Warehousing / Logistics, Office, and Cafe / Restaurant Development at Calmount Road

Engineers Response to Further Information
Request

210175-DBFL-TR-XX-RP-C-0004

Figure 13- Realigned Footpath and Cycle Track in the South-East corner of the Development Site

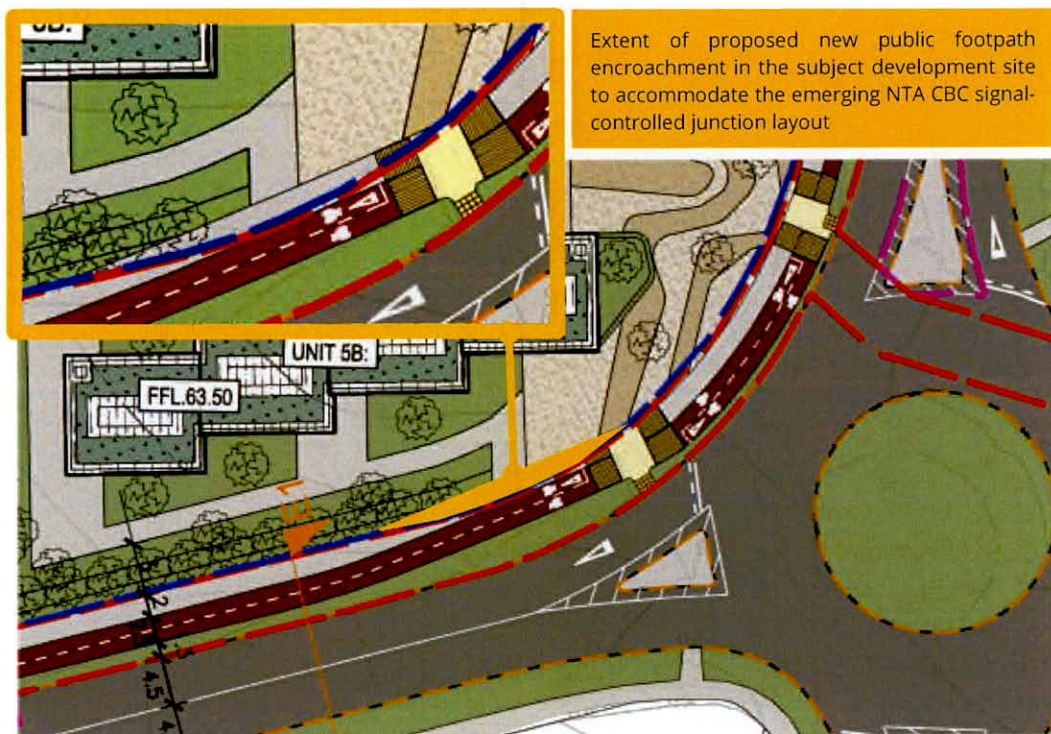
Please see accompanying DBFL drawing 210175-DBFL-TR-SP-DR-C-1019 which details how the proposed development has been updated in response to SDCC FIR. The amended layout now includes an encroachment into the south-east corner of the subject site which accommodates the inclusion of a new section of footpath and the realignment of cycle track within the application site the extent of which is to be offered to be adopted by the

local roads authority. This amendment enables (i) the proposed external off-site cycle track to be continued uninterrupted around the southeast corner of the site (between Calmount Rd and Ballymount Avenue in the short-term scenario that the existing off-site Calmount Rd / Ballymount Avenue roundabout is retained in-situ), and (ii) ensures the successful integration of the proposed development and associated offsite active travel infrastructure enhancements with the emerging NTA's Bus Connects Core Bus Corridor (CBC) signal-controlled junction arrangement at this off-site junction (which will replace the existing roundabout arrangement in the future).

Figure 21 – Potential Signal Controlled Arrangement at the Calmount Rd Site Access Junction

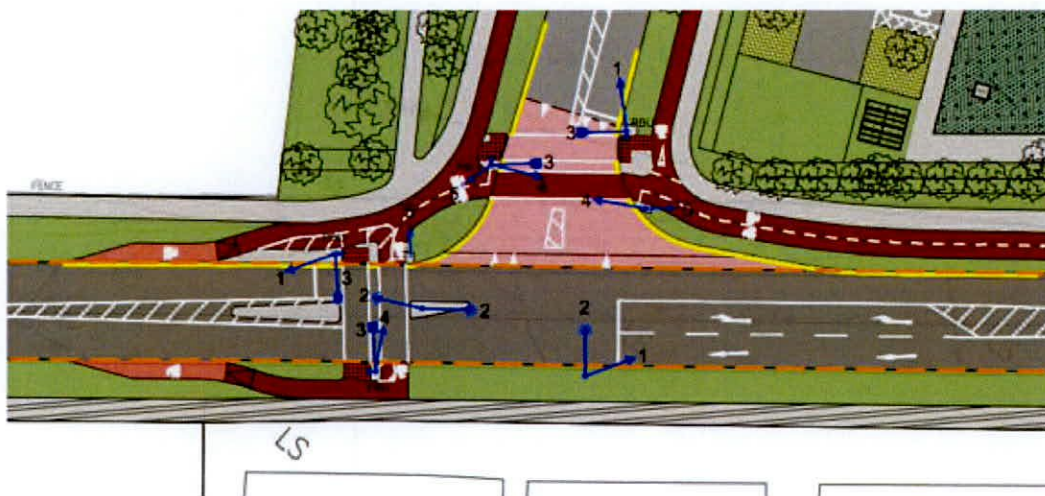
The FIR stated a *“revised layout of the Calmount Road access as a junction type to provide for the future link road.”* The proposed ‘ghost island’ priority-controlled junction arrangement now being proposed for the Calmount Rd site access as part of the applicant’s response to the FIR has the flexibility to also accommodate any potential increase in traffic movements that this junction may experience once the SDCC objective for the *“future link road”* to Ballymount Road Lower is delivered in the future.

Nevertheless, whilst the FIR statement for a *“junction type”* is unclear DBFL have compiled a preliminary design of a fully signal controlled junction arrangement for this junction to demonstrate how the proposed ‘ghost island’ priority-controlled junction arrangement being implemented by the applicant can readily be upgraded in the future to a signal controlled layout with minimum civil works required. This potential future signal controlled junction arrangement is presented in Figure 21 below and in DBFL drawing 210175-DBFL-TR-SP-DR-C-1022.

Figure 24 – Calmount Rd Site Access Junction Pedestrian and Cycle Connections

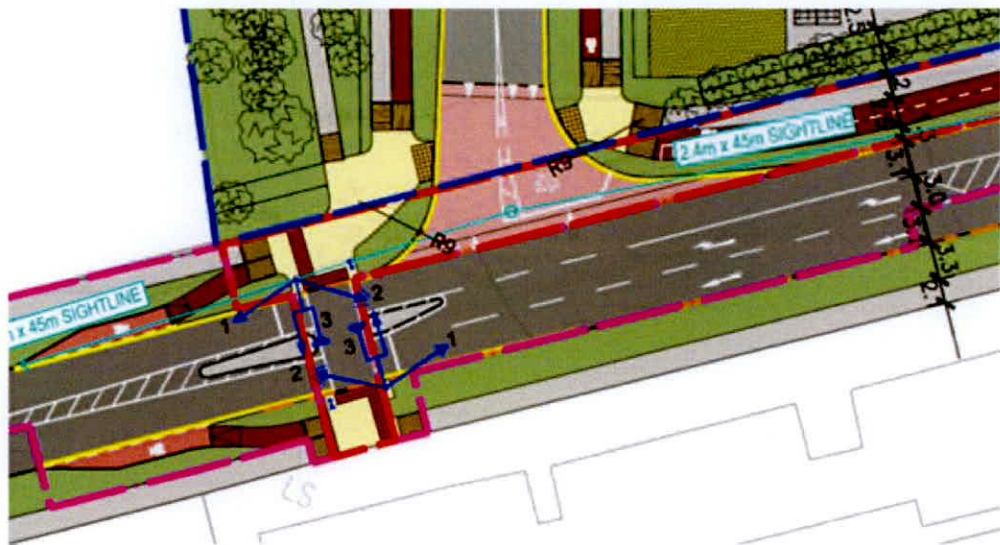
- **Calmount Rd Site Access** – In response to both the SDCC FIR and recommendations raised with the commissioned Quality Audit the design of the site access junction on Calmount Road has been revisited. A TOUCAN crossing is provided on Calmount Rd to facilitate the safe passage across the carriageway whilst a raised flat top ramp in accordance with the National Cycle Manual is provided on the minor arm to accommodate pedestrian and cycle connectivity along the northern side of the Calmount Rd corridor and through the new site access junction. As there is no cycle infrastructure provided to the southwest of the site access junction on Calmount appropriate transition facilities have been incorporated into the design to enable cyclists travel between the road carriageway (to/from the southwest) and the off-site cycle tracks (to the east of the site access junction). Further to Figure 24 additional details are provided in drawing 210175-DBFL-TR-SP-DR-C-1019.

Figure 25 – Internal Active Travel Road Crossing Facilities (North-South Access Road)

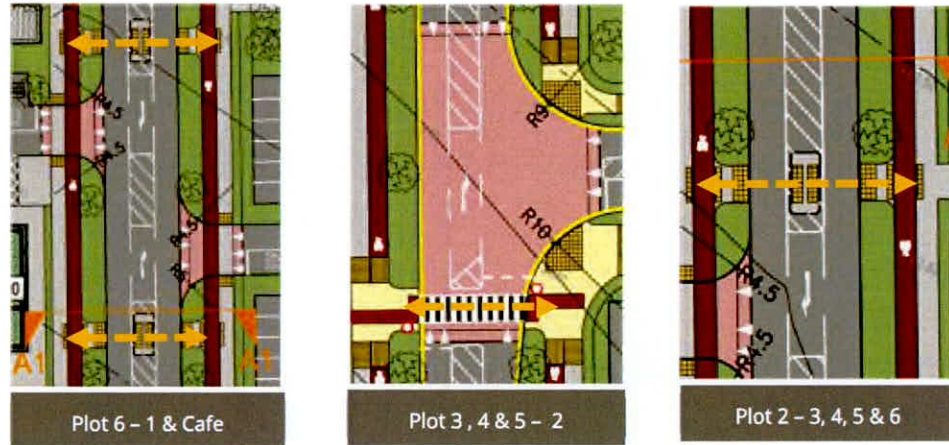
- **Internal Access Road** – In response to the SDCC FIR a number of new active travel crossing facilities have been incorporated into the updated scheme proposals. Considering the number of access points to/from the different internal development plots a balance has been sought to be achieved were the new crossing facilities would accommodate access to and from a number of adjoining plots. Further details

of these new internal active travel crossing facilities are presented in Figure 25 additional details are provided in drawing 210175-DBFL-TR-SP-DR-C-1019.

Figure 27 – New 2.0m wide Footpath between the Calmount Rd Site Access and Ballymount Rd Upper

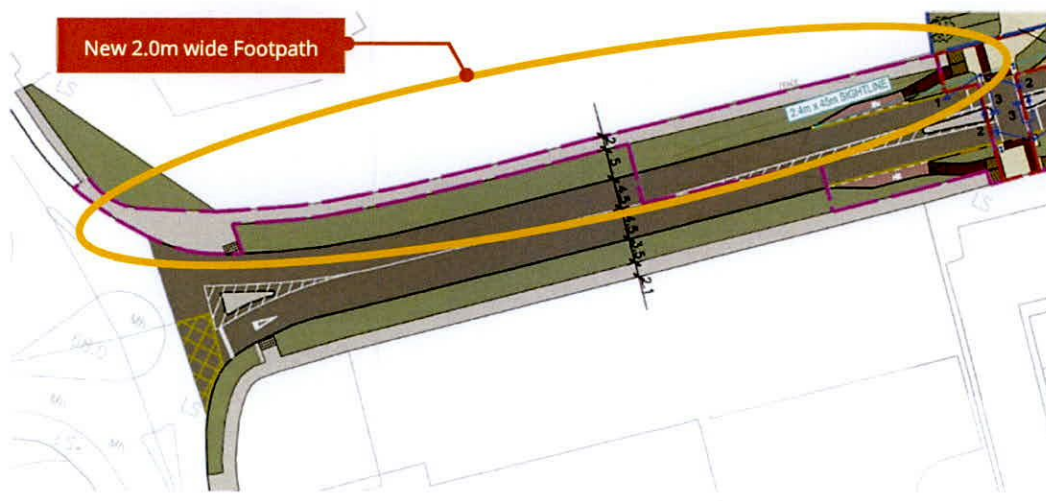
As per the SDCC request the scheme proposals have been updated to include the provision of a new 2.0m wide concrete footpath along the northern side of Calmount Rd corridor between the proposed site access junction and the existing Calmount Rd / Ballymount Rd Lower tear-drop roundabout junction.

Whilst the details / alignment of this new pedestrian connection can be amended / conditioned in response to SDCC specific requirements, the presented alignment seeks to position this new footpath in close proximity to the existing northern boundary treatment with the objective of retaining a grass verge (criteria 5.0m) wide between the new footpath and the existing road carriageway with the objective of retaining the maximum level of flexibility to accommodate any future enhancement works that SDCC may seek to implement along this corridor in the long term. The extent of this new footpath is graphically presented in Figure 27 below and DBFL drawing 210175-DBFL-TR-SP-DR-C-1019.

Drawing 210175-DBFL-TR-SP-DR-C-1019, Calmount Road

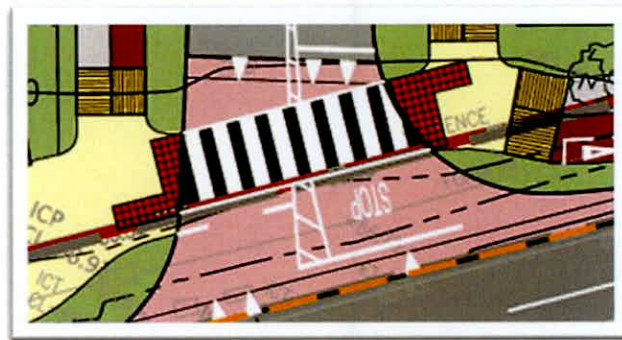
The drawing shows a zebra crossing at the junction on Calmount Road. Given the volume of HGV traffic, such vehicles will be overhanging the Calmount Carriageway when allowing pedestrians and cyclists to cross. This could result in rear-end collisions.

It is recommended that an uncontrolled crossing be provided whereby drivers can continue to turn when pedestrians and cyclists are clear of their path.

Drawing 210175-DBFL-TR-SP-DR-C-1019, Calmount Road, uncontrolled pedestrian crossing.

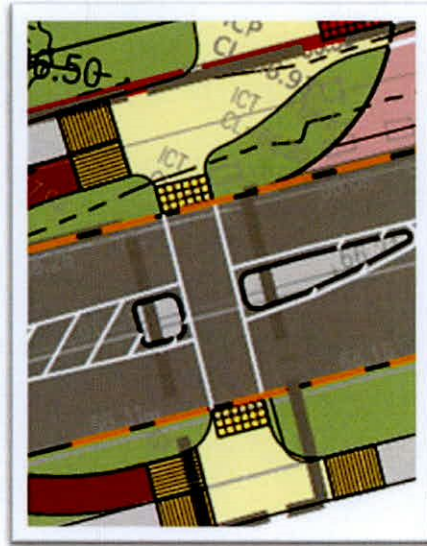
The drawing shows an uncontrolled pedestrian crossing of Calmount Road however road marking tram lines suggest a controlled crossing. This may lead to confusion over priority between drivers and pedestrians resulting in collisions.

It is recommended that the crossing be upgraded to a controlled crossing.

Drawing 210175-DBFL-TR-SP-DR-C-1019, Ballymount Avenue.

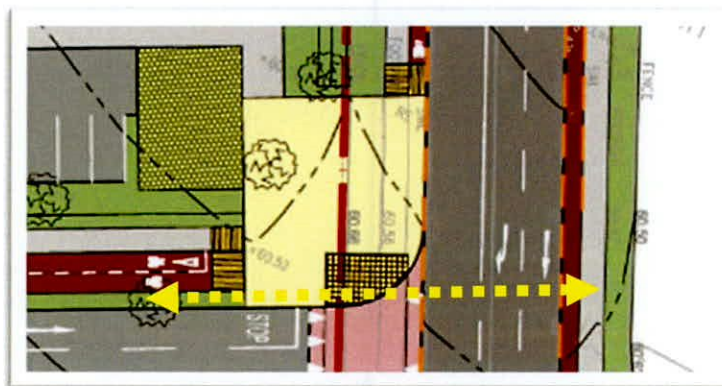
There is a discontinuity in cycle facilities between the south bound cycle lane on Ballymount Avenue and the two-way facility within the development. Cyclists may travel cross at the right turning lane for vehicular traffic could lead to collisions with turning HGVs.

Drawing 210175-DBFL-TR-SP-DR-C-1019

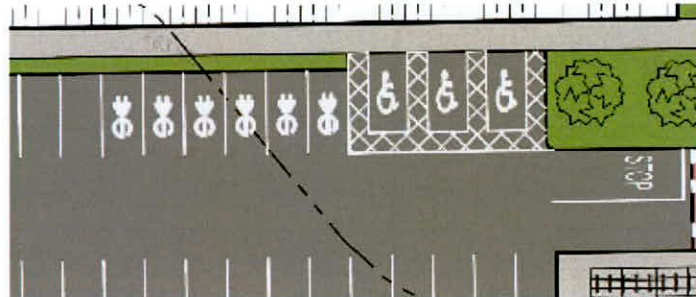
The dimensions of the electric vehicle charging points are not clear, or the location of the charging unit. Cables from this unit may be left lying on a footpath which could be a slip hazard for vulnerable road users resulting in slip/fall type injuries.

Drawing 210175-DBFL-TR-SP-DR-C-1019

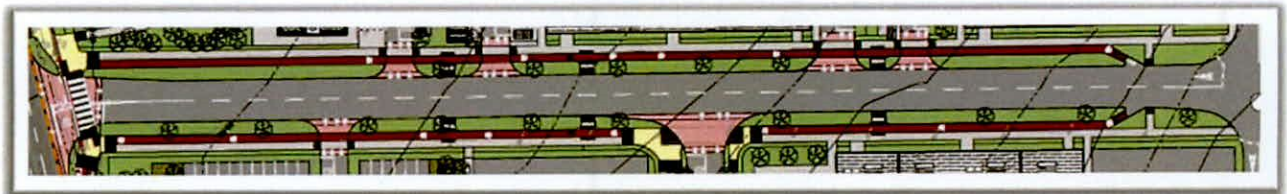
The main internal north-south road widths are not dimensioned, including footpaths, cycleways etc. The audit team are concerned that this long straight road could result in higher speeds which could put vulnerable users using the crossing points at risk of collision resulting in injury.

Drawing 210175-DBFL-TR-SP-DR-C-1019

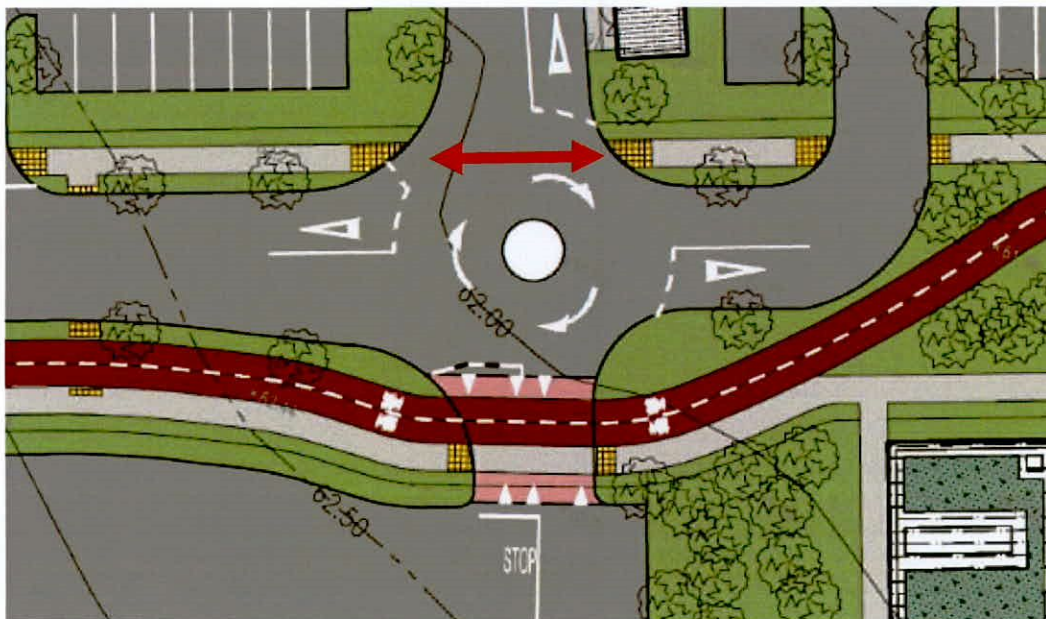
The crossing point to the north side of the roundabout is located within the circulating carriageway of the roundabout. Crossings at inappropriate locations increase the risk of pedestrian/vehicular collision leading to injury.

Drawing 210175-DBFL-TR-SP-DR-C-1019

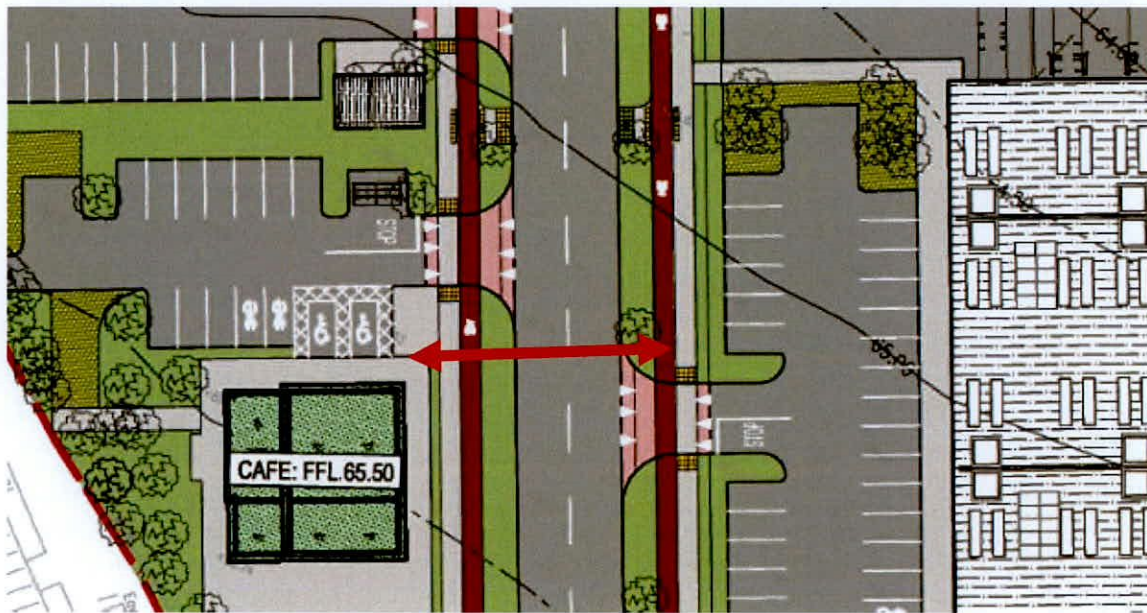
A pedestrian desire line exists from Unit 6 to the café. No crossing point has been provided on this desire line leading to an increased risk of vehicle/pedestrian collisions due to likelihood of pedestrians crossing at unsafe locations.

Drawing 210175-DBFL-TR-SP-DR-C-1019

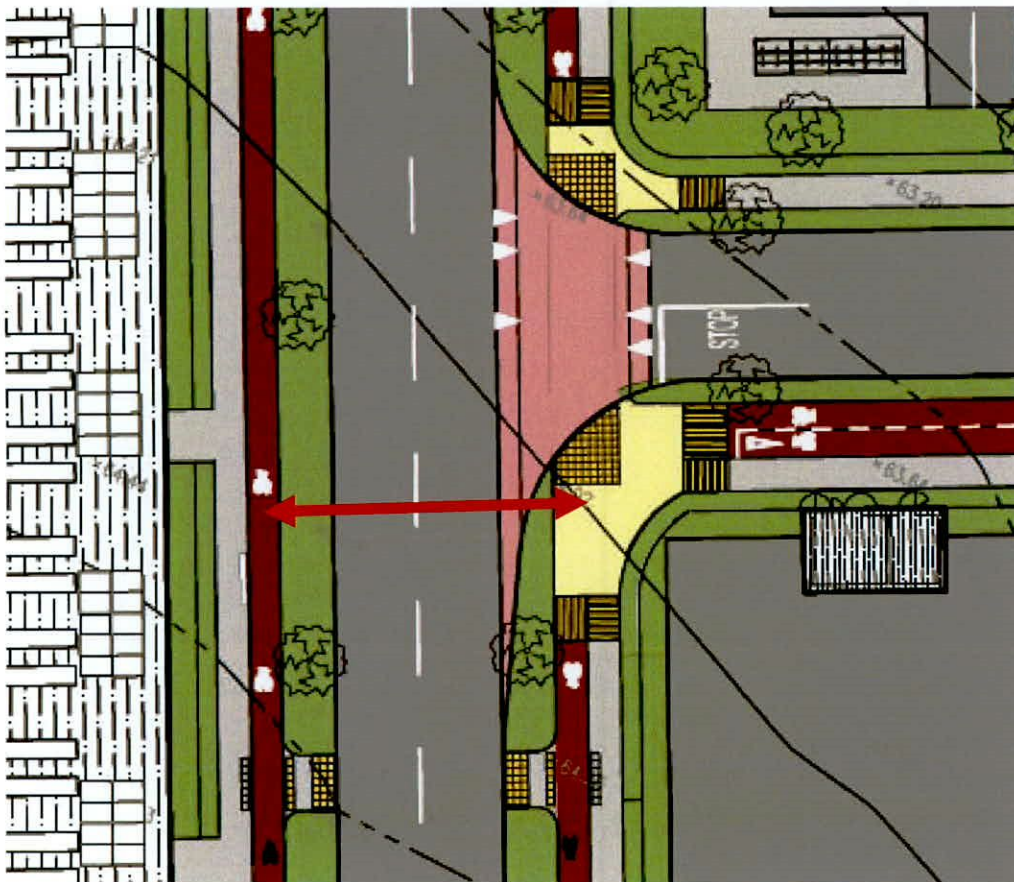
There will be a desire for cyclists to cross at this location given the termination of the two-way cycle track to the east of the junction. This cyclist discontinuity increases the risk of a collision between vehicles and cyclists who cross at undesignated locations.
